DESIGN+PLACE SEPP EIE RESPONSE

Date	28 th April 2021
------	-----------------------------

ADG : POTENTIAL RESPONSE CONTENT (TO PROPOSED DESIGN CRITERIA)

FIGURE B1 TYPICAL CLASS 1 PARKING FACILITIES WITH BICYCLE LOCKERS

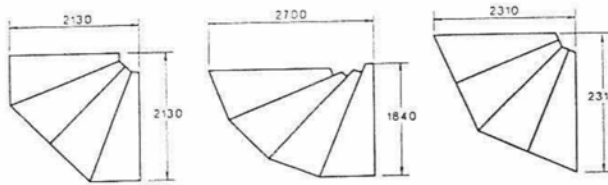
- Bikes: 1 x secure space/1bed,2 x secure spaces/2 bed, 3 x secure spaces/3 bed: presumes 100% bike usage which is a substantial spatial requirement and highly unlikely in a city fraught with steep topography
- **RECOMMENDATION:** maintain current rates but support a centralised bike storage in addition to cater for additional bike uptake / development (perhaps a ratio per dwelling numbers)
